STATE OF ALASKA
DEPARTMENT OF TRANSPORTATION AND PUBLIC FACILITIES

Hoonah Alaska

GENERAL LAYOUT

PROJECT NUMBER X 70006 SHEET 2 OF 6

V22/B5	AS BUILT 1-14-86		
STAMP	DO NOT SCALE THIS DRAWING - USE DIMENSIONS		
	STATE OF ALASKA		
	DEPARTMENT OF TRANSPORTATION AND PUBLIC FACILITIES		
	Hoonah	Alaska	
MISC. DETAILS			
DESIGNED LJB	CHECKED JS	DRAWN LJB	DATE 10/84
PROJECT NUMBER X70006	SHEET 4		OF 6

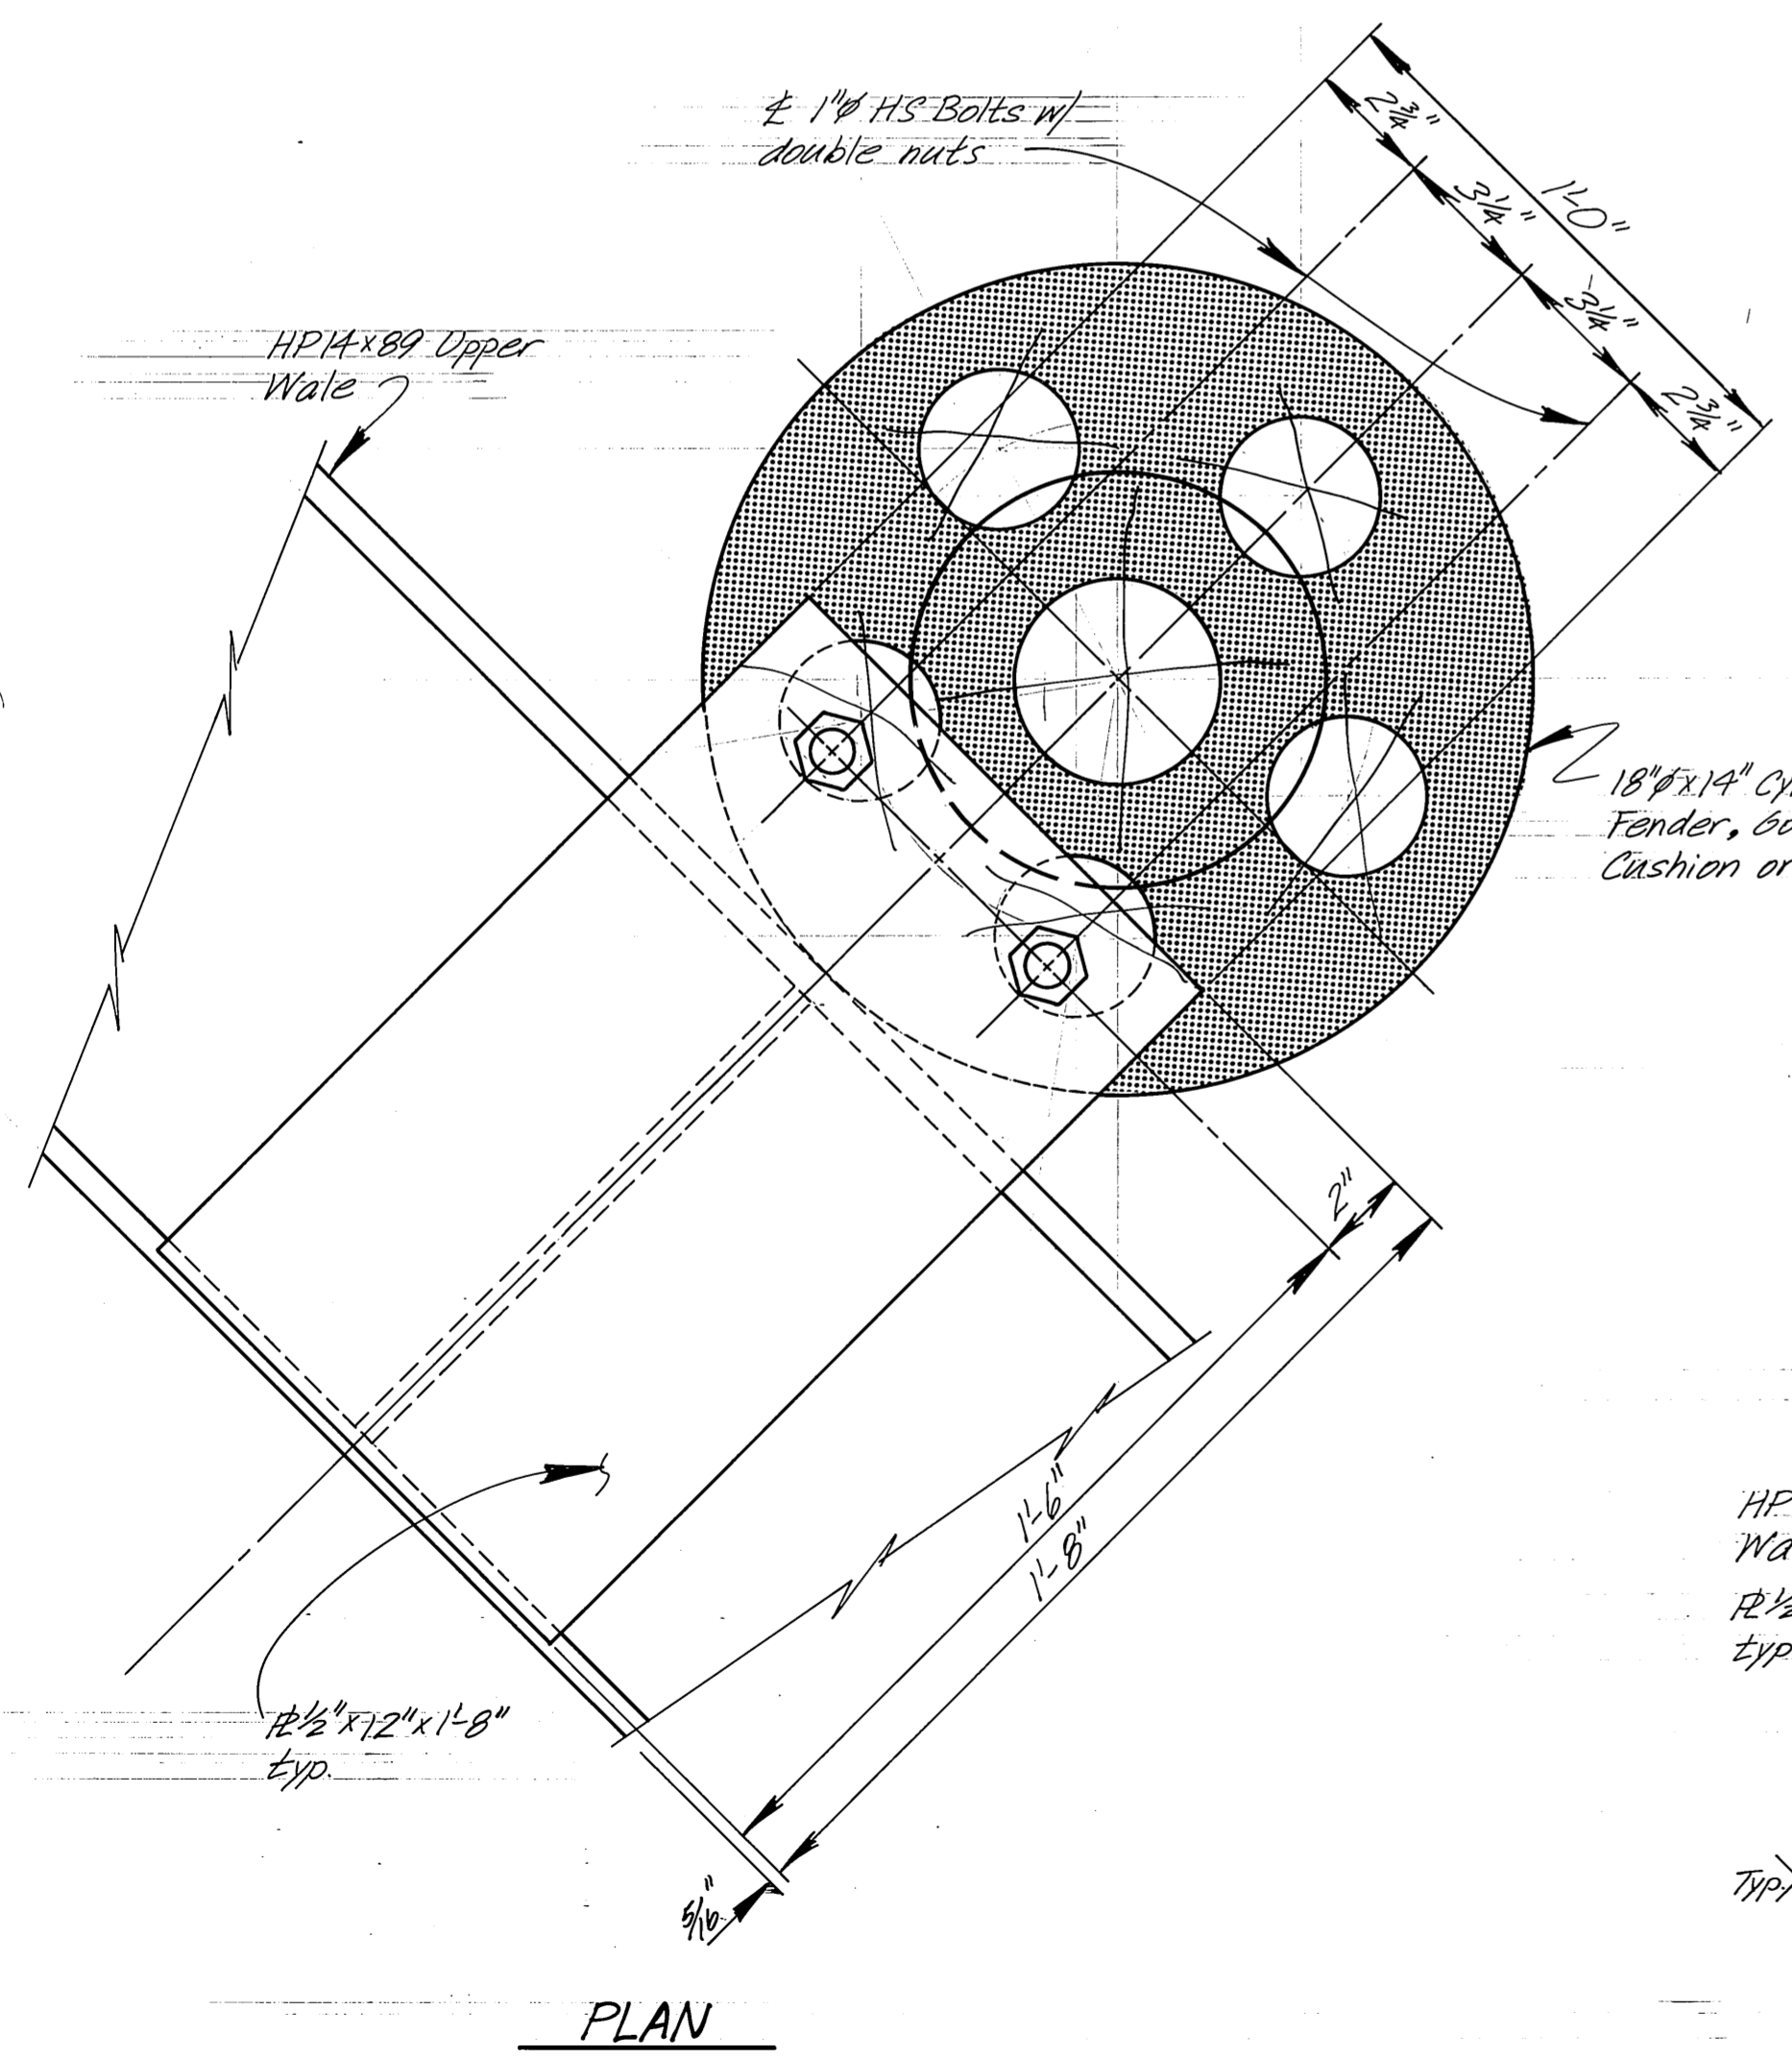
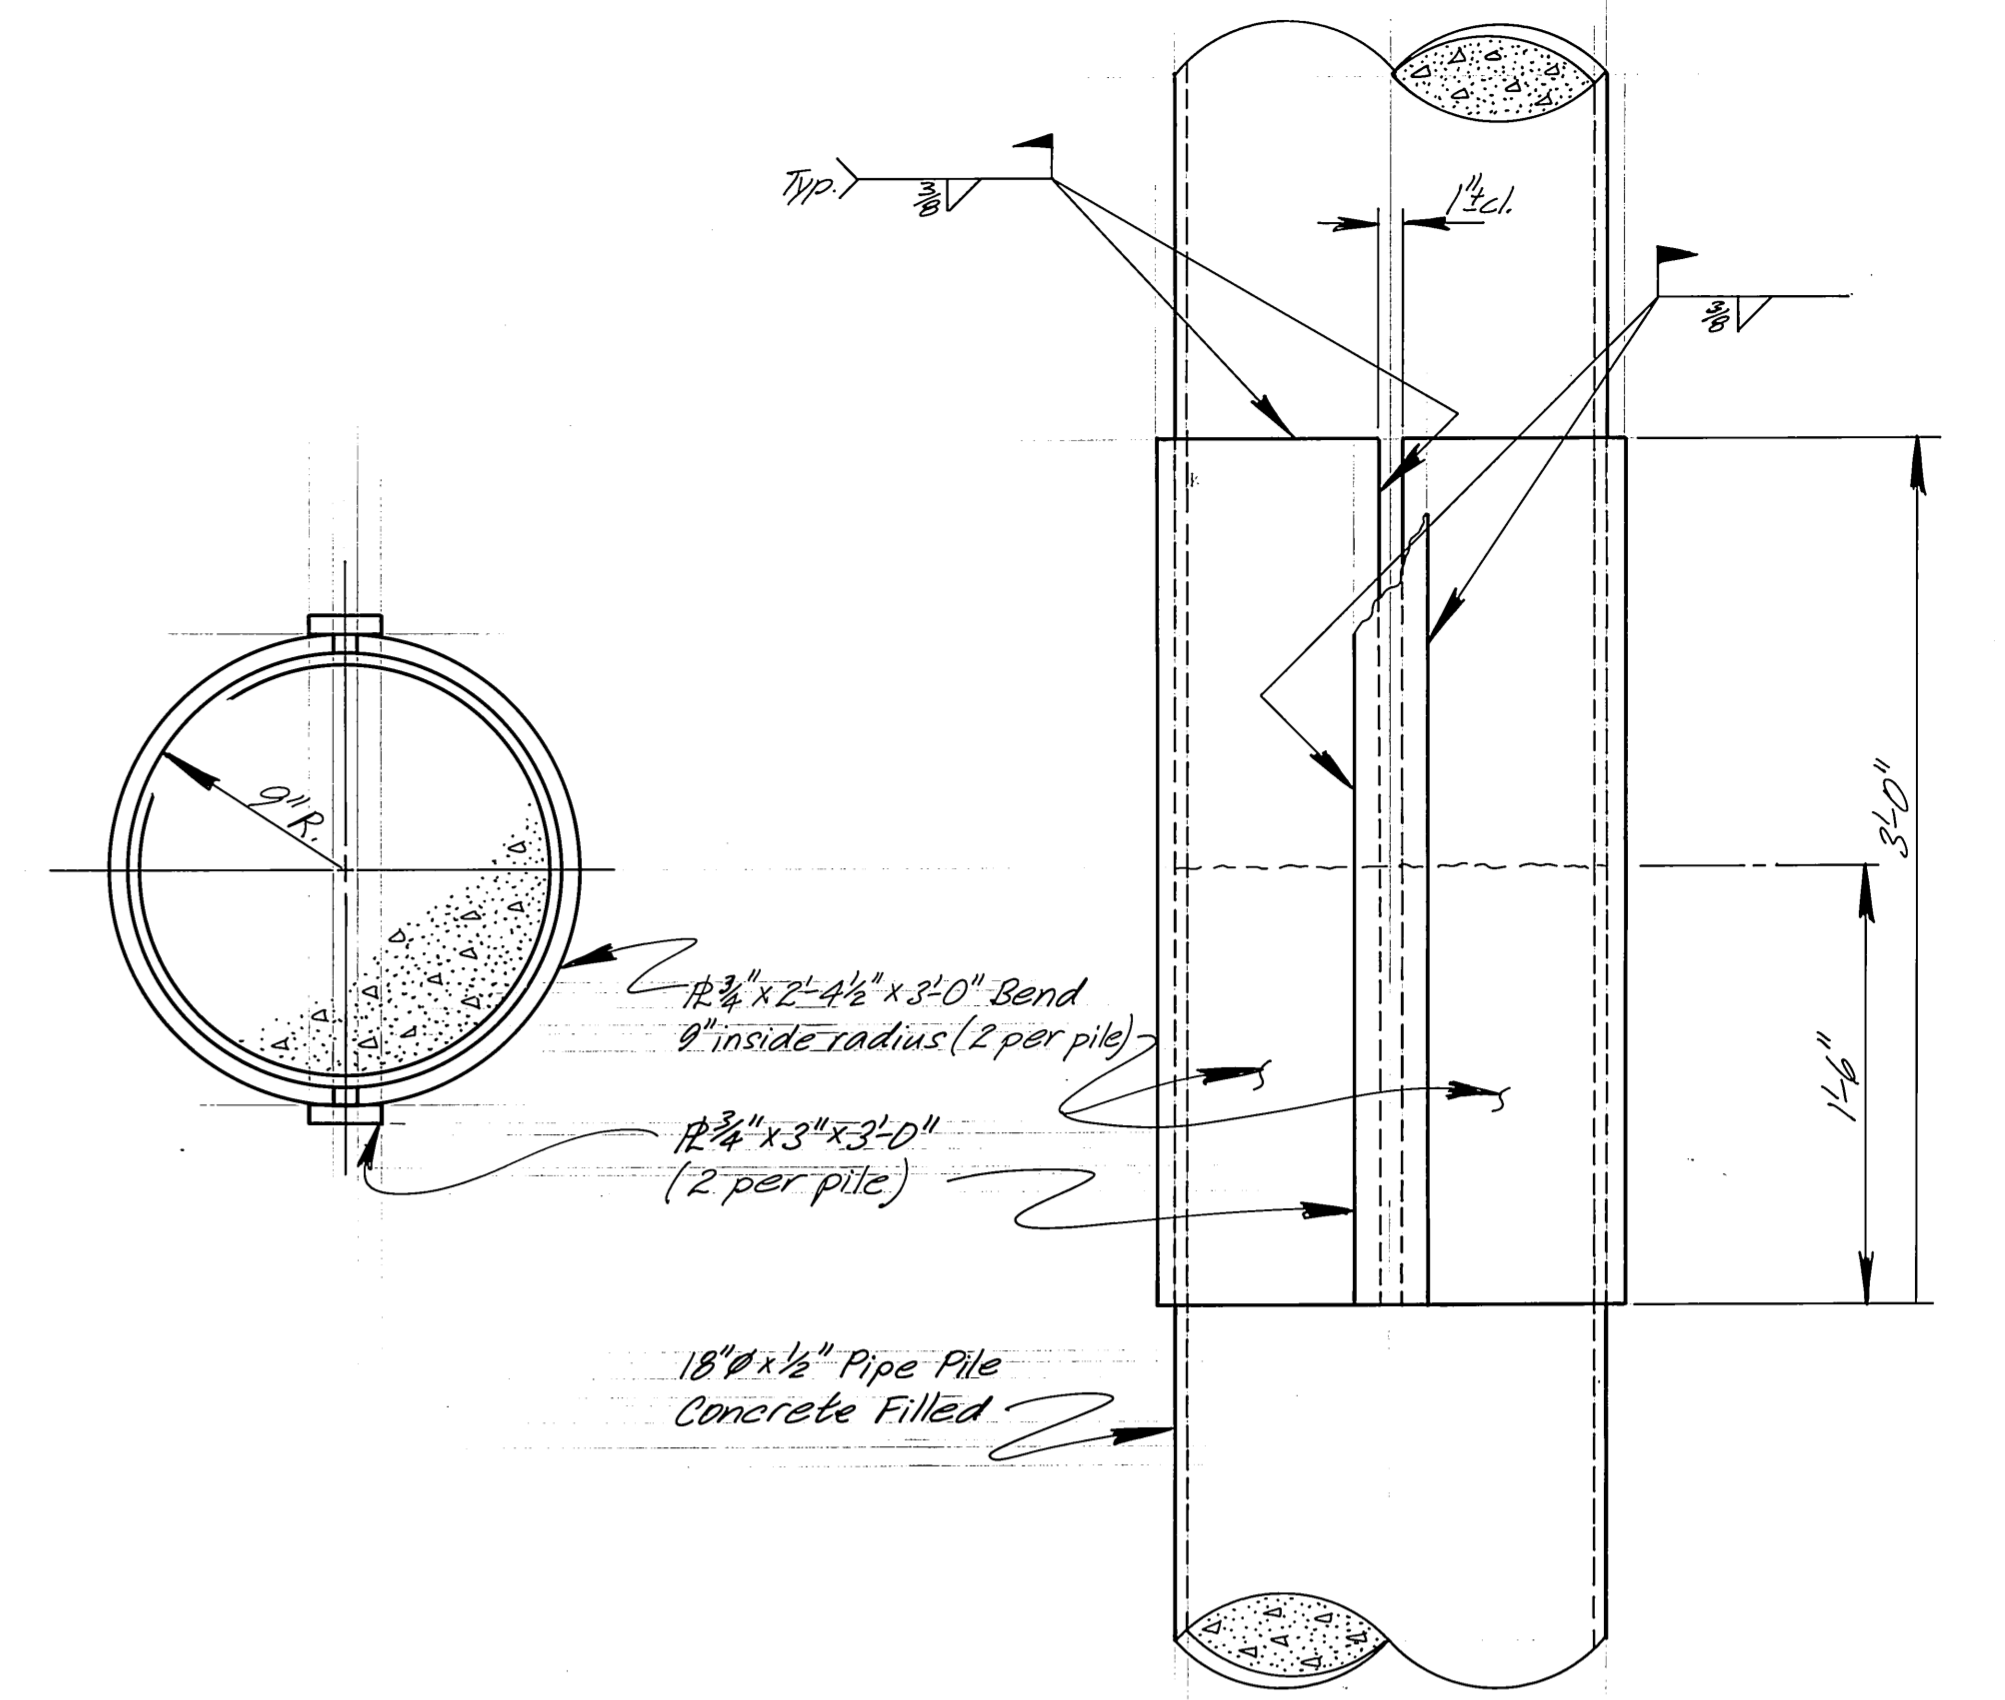
AS BUILT NOTE: Supplement "A" not awarded. 18" O.D. x 9" I.D. rubber fender substituted.
